PLANT NAME: Bellefonte

ENCLOSURE I

REQUEST FOR ADDITIONAL INFORMATION
TENNESSEE VALLEY AUTHORITY
BELLEFONTE NUCLEAR PLANT, UNITS 1 & 2
DOCKET NOS. 50-438 AND 50-439

ENCLOSURE II

FIGURE 9.55-1

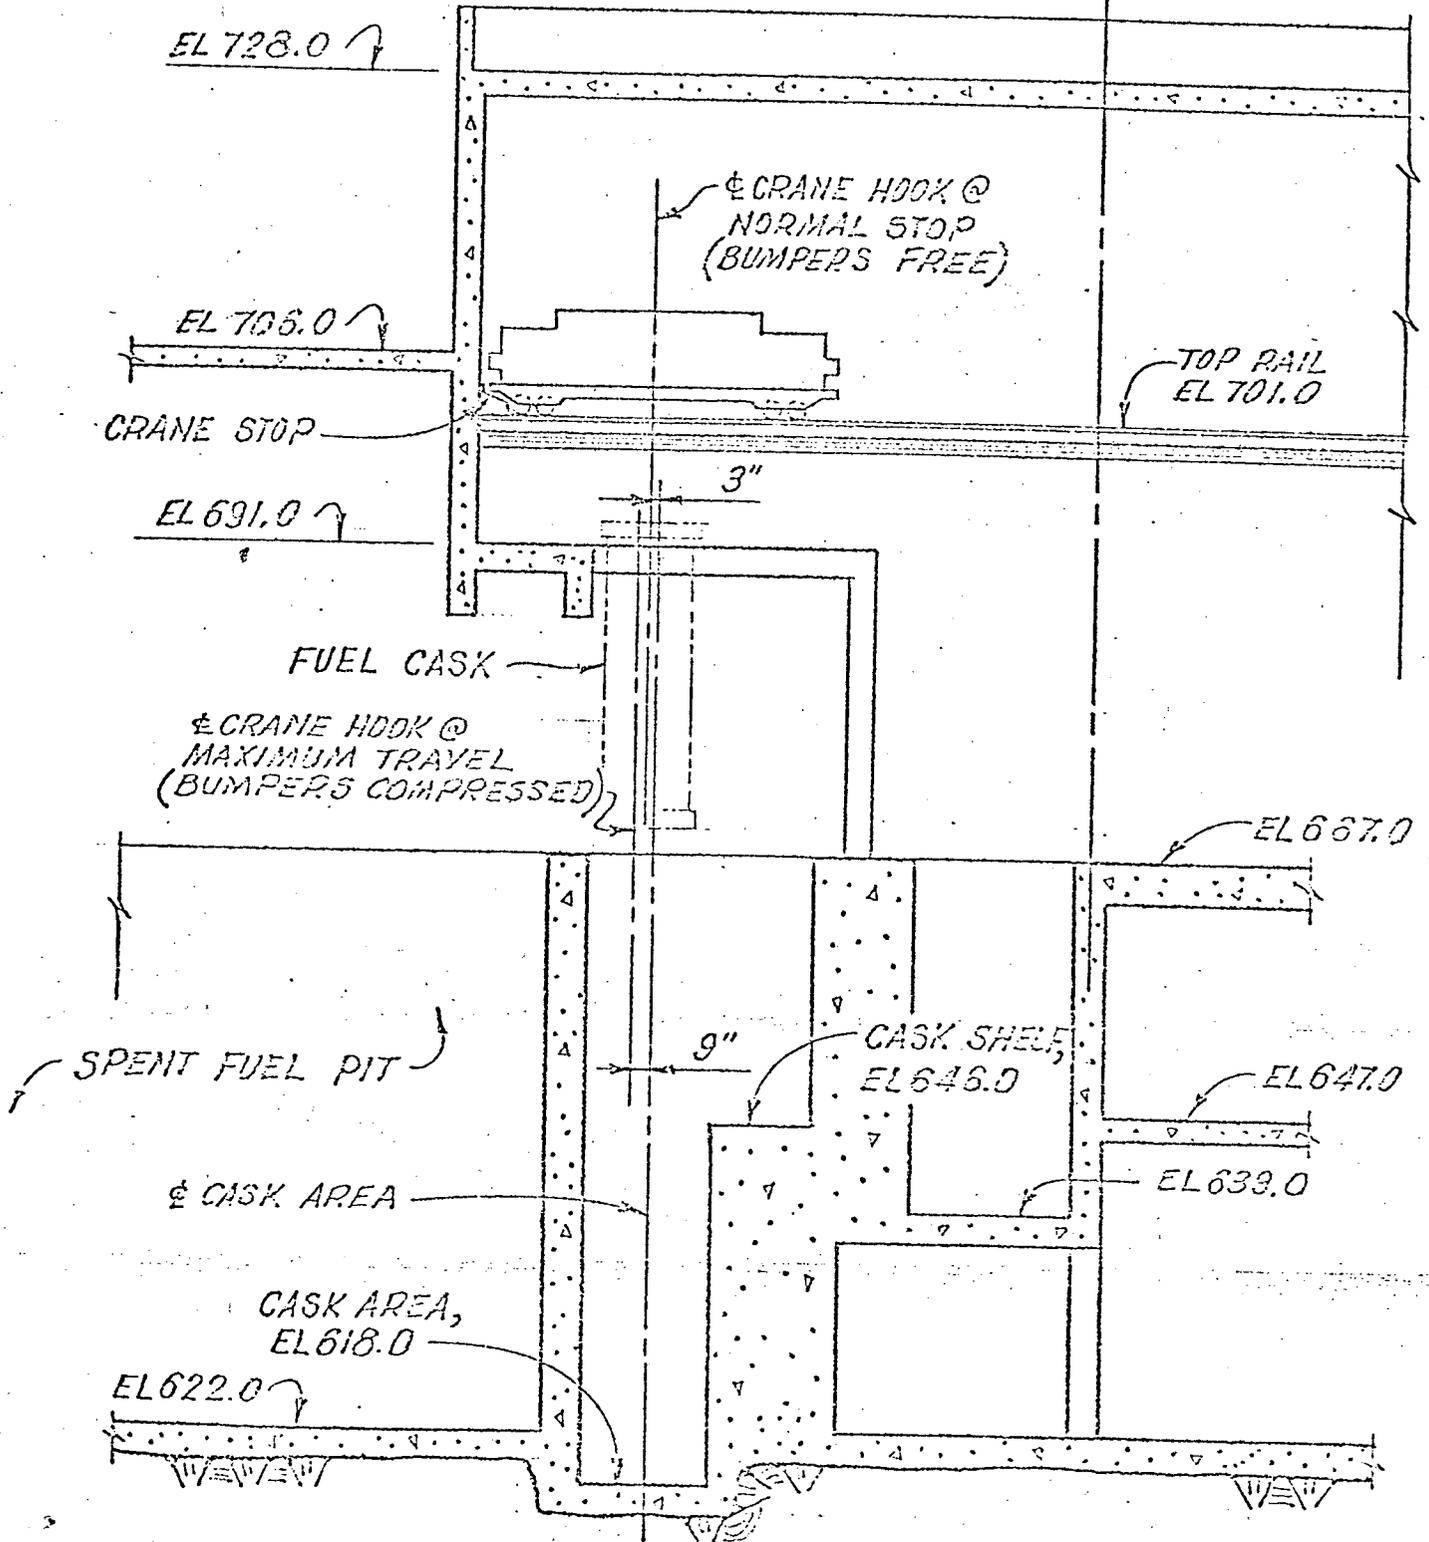
In your response to Request 9.23, regarding the effects on the separating wall and the fuel pool in the event that a cask is dropped in the tipped position, it is stated that the crane will be moving at a very slow rate and if a cable should break over the cask loading area, the cask will be tipped in the north-south direction. However, an examination of Figures 9.1-4 and 9.1-5 indicates that the top of the 150 ton overhead crane rail overlaps the spent fuel pool area. Thus taking this into consideration in conjunction with the velocity vector of the cask, it appears that the possibility of a cask falling into the fuel pool may not be as remote as it has been suggested.

It is requested that you provide either a modification of the rail arrangement or an analysis indicating the velocity, momentum and the resultant external forces of the cask to support the conclusions you have reached.

Although the rail for the 150 ton crane overlaps the spent fuel area, no part of the fuel cask and the crane hook can pass over any part of the spent fuel area. The relationship of the spent fuel area, the cask area, the crane, the hook, and the fuel cask to each other is shown in Figure 9.55-1 which shows an up-to-date detail of part of section A-A on Figure 9.1-5 in the PSAR. The slab and beam at elevation 700.0 has been lowered to elevation 691.0 to prevent the cask from swinging over the spent fuel pit. The crane hook is located at the centerline of the crane so that the hook and the cask must stop at about 15 feet from the end of the crane rail. The crane stop will be designed to take the full load, plus impact, of the crane. The crane will have a six-inch bumper on it which will cushion the impact and stop the crane centerline somewhere between three inches and nine inches west of the centerline of the cask area. In view of the layout of the spent fuel pit, the cask area, the rail stop, and the crane hook, we consider it ~~impossible~~ impossible for the cask to fall into the spent fuel pit.
